# GEOTECHNICAL MEMORANDUM

**Date:** 15 August 2022

**Project:** Grey Gully Bridge – Geotechnical Reassessment and Redesign

# Design Drawings Revised

**Figure 1: Section view of revised reinforcement – Grey Gully South.**

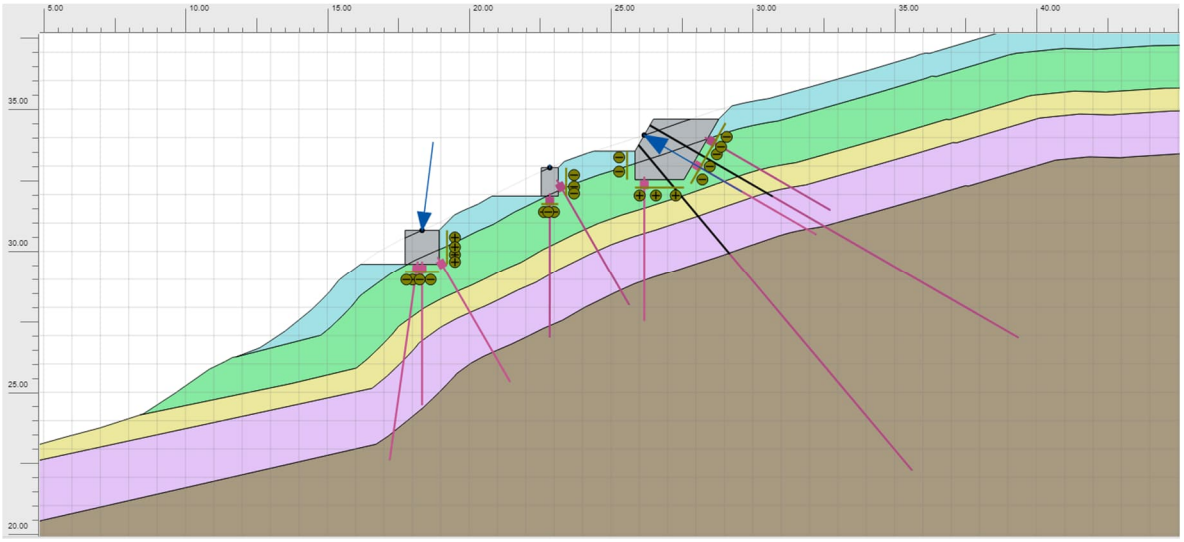
Figure 1 and Figure 2 provide section views of the revised reinforcement for each bridge abutment. **Appendix A** has a revision of the existing design drawings with the revised details annotated therein.

ANCHOR–DETAILS

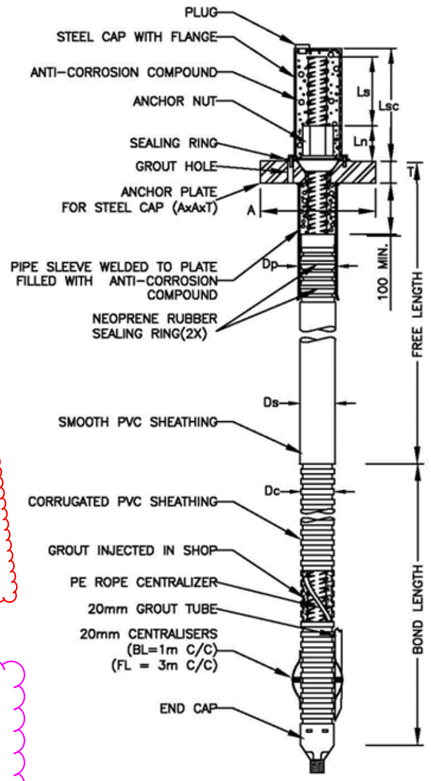
Text to be removed as it also written below.

**ANCHOR BLOCK ELEVATION**

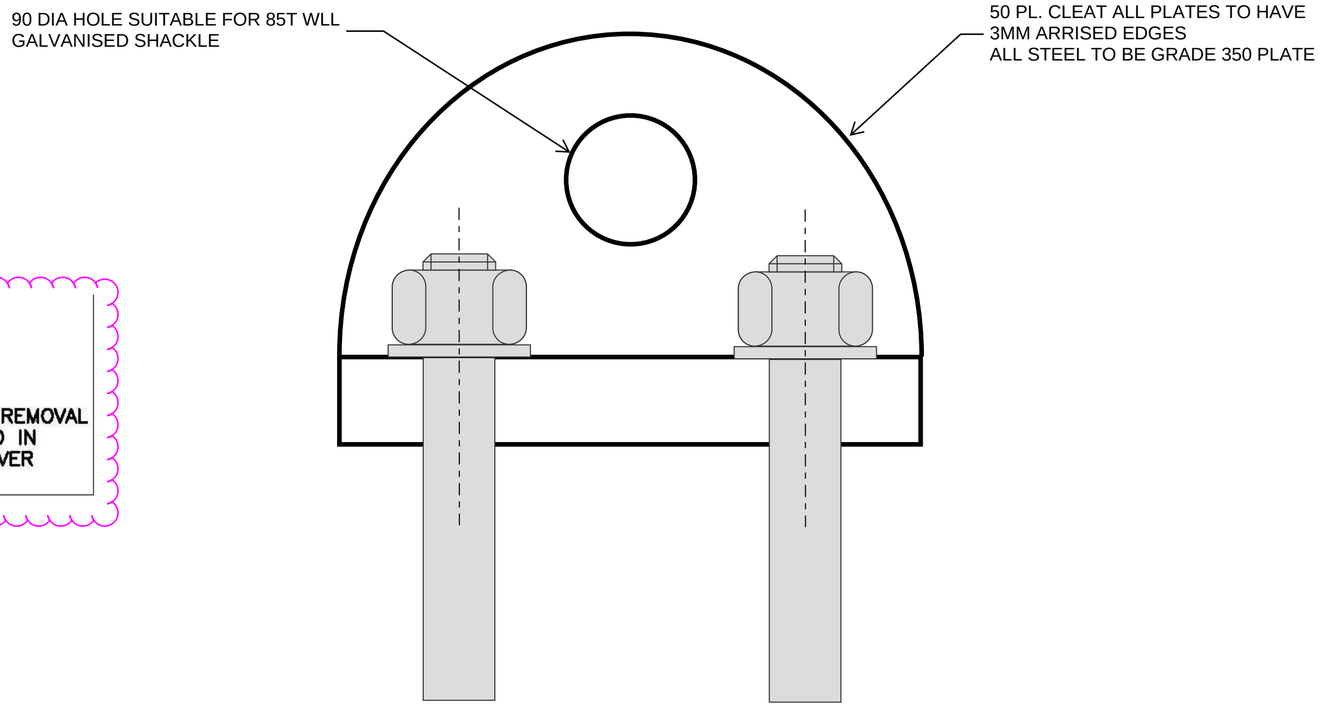
Drawing is to also include the DWG-PermStrand01 - Permanent Strand Anchor Details as attached in this report.

**PORTAL FOOTING - PLAN**

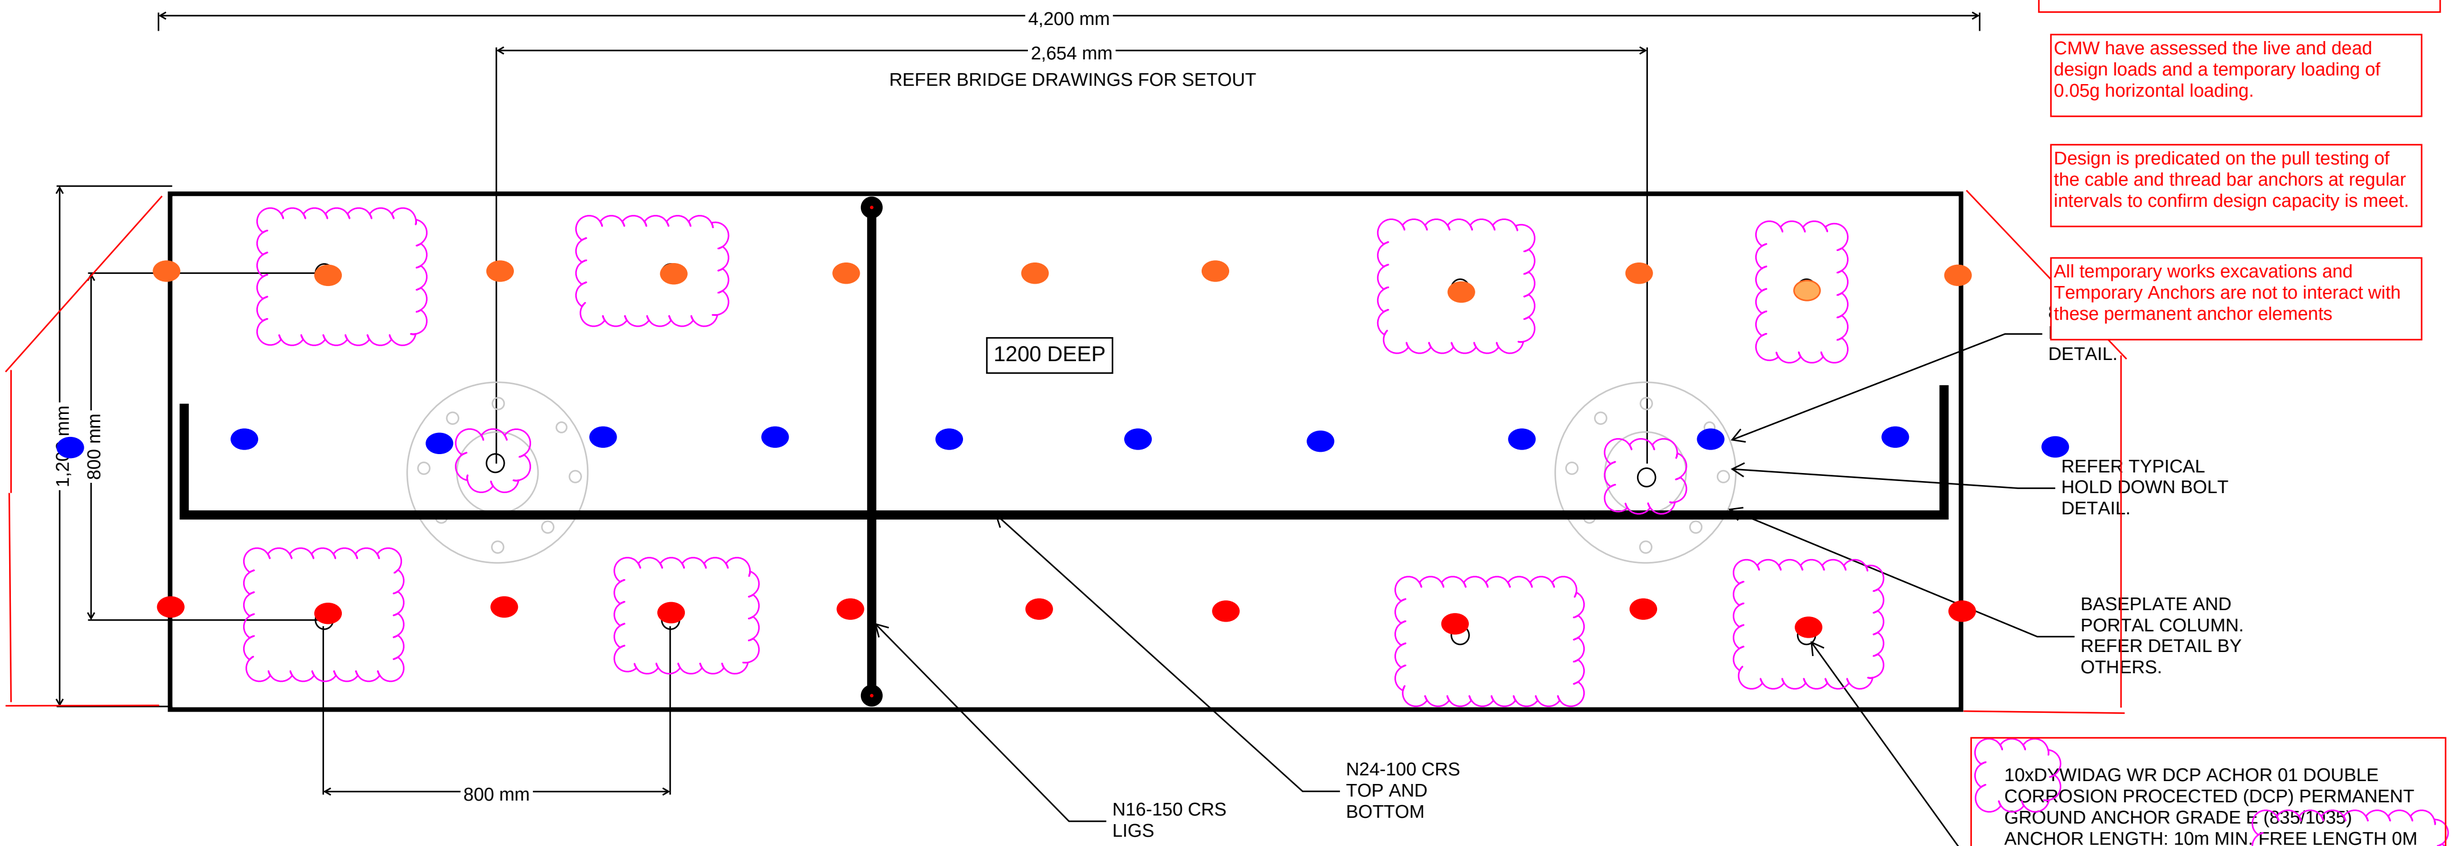
Raked DCP 40mm threaded bar, inclined 60 degree from the horizontal into the slope. Embedded into the strip footing. 7mL.

DCP 40mm threaded bar, inclined 90 degree. Embedded into the strip footing. 5mL.

DCP 40mm threaded bar, inclined 90 degree. Embedded into the strip footing. 7mL.

text to revised to 40mm threaded DCP bar.

**PORTAL FOOTING - SECTION**

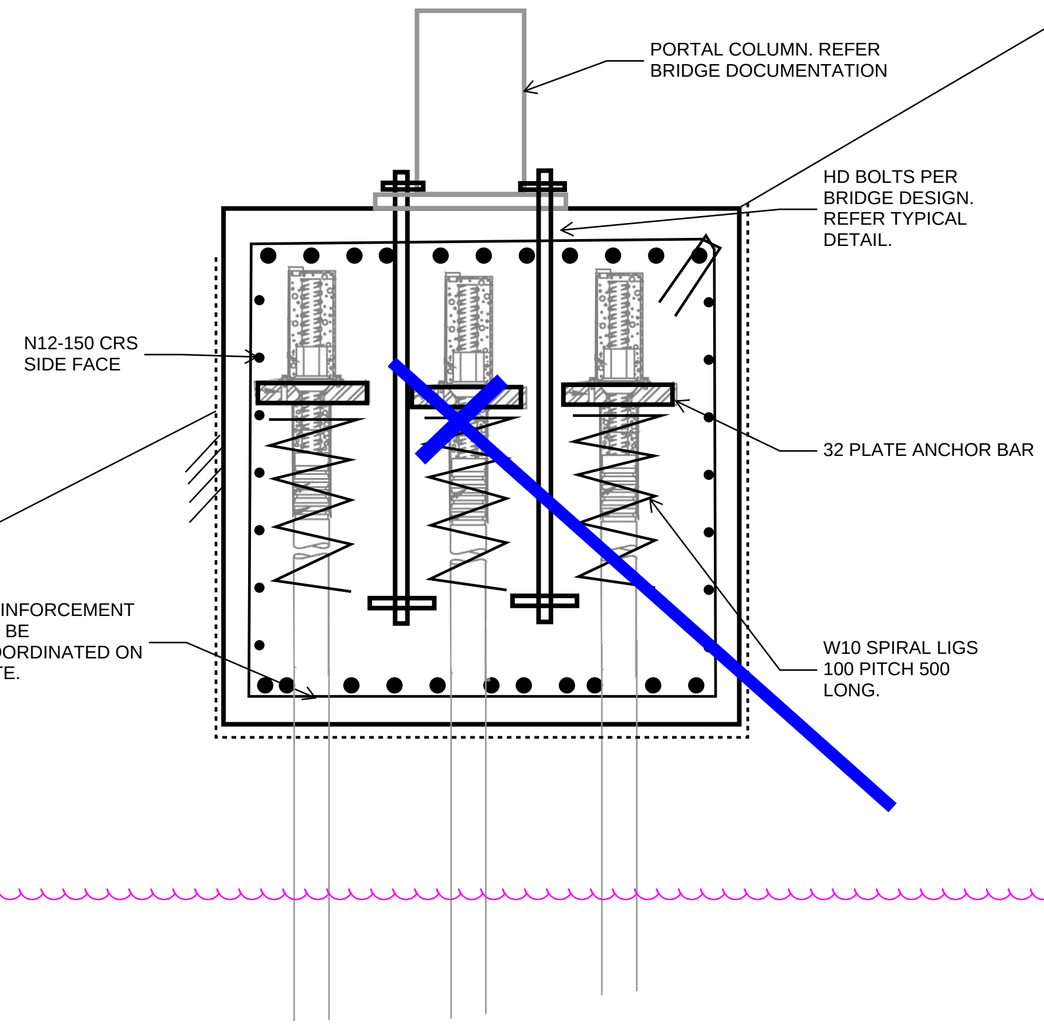
In above section - central 40mm DCP threaded bar is inclined / raked into slope (see blue line)

**BRIDGE LANDING FOOTING - PLAN**

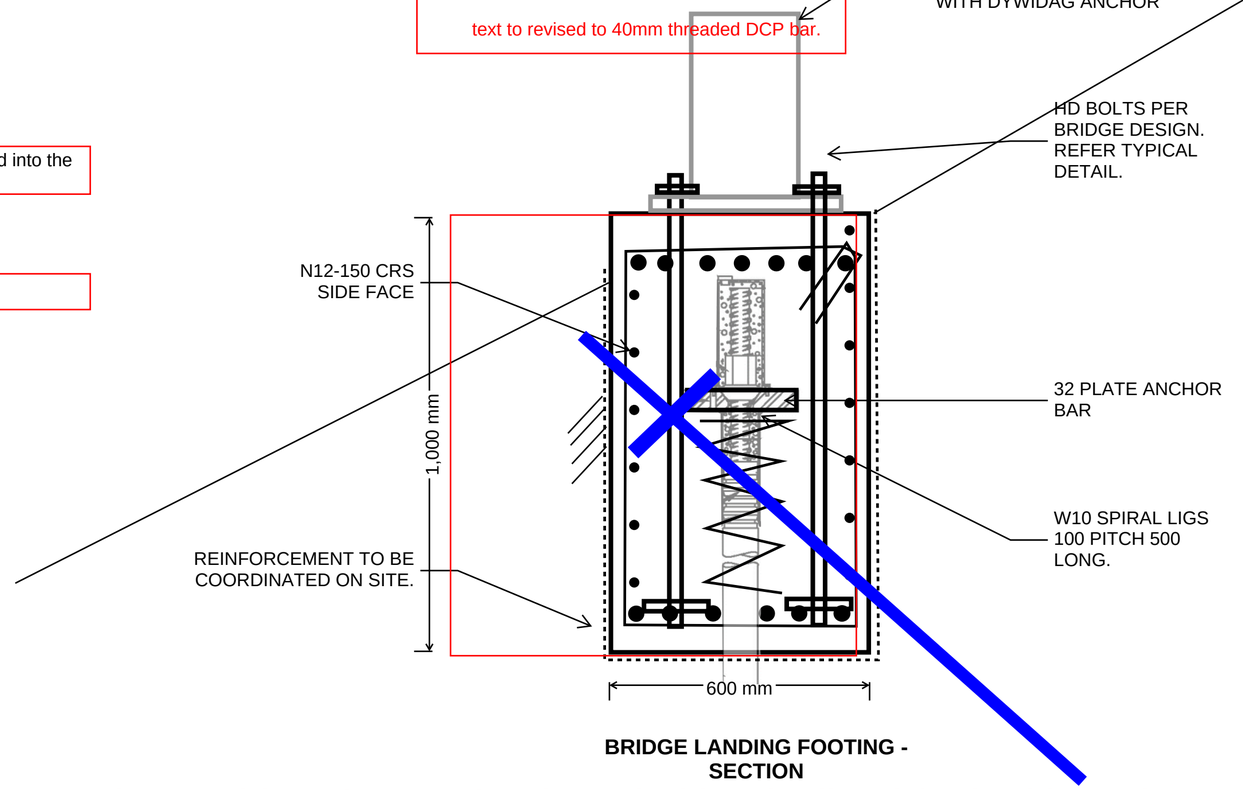
Raked DCP 40mm threaded bar, inclined 60 degree from the horizontal into the slope. Embedded into the strip footing. 6mL.

DCP 40mm threaded bar, inclined 90 degree. Embedded into the strip footing. 6mL.

**BRIDGE LANDING FOOTING - SECTION**

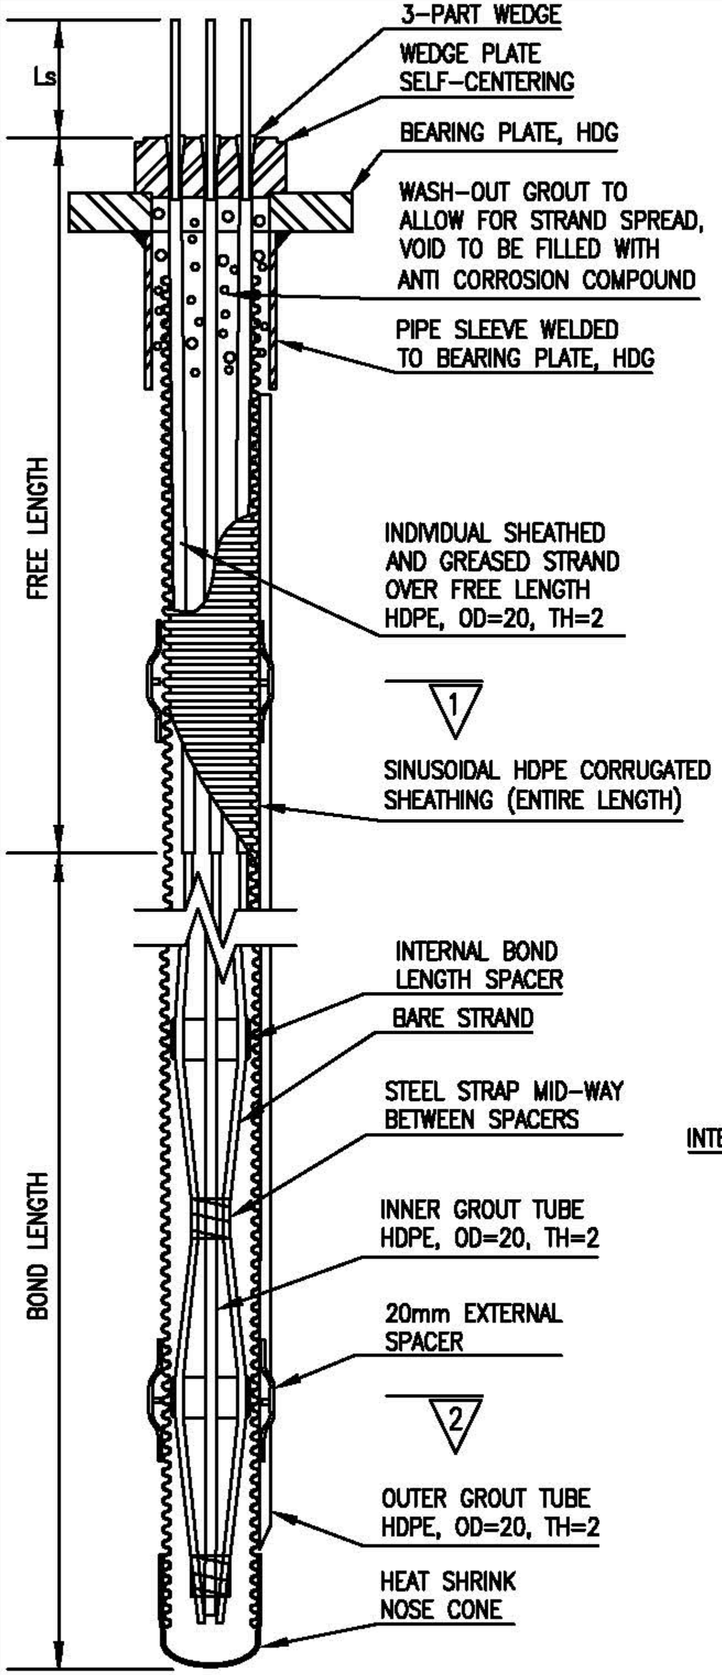
In above section - add a 40mm DCP threaded bar inclined / raked into slope (see above blue line). This is likely to change the dimensions of the block
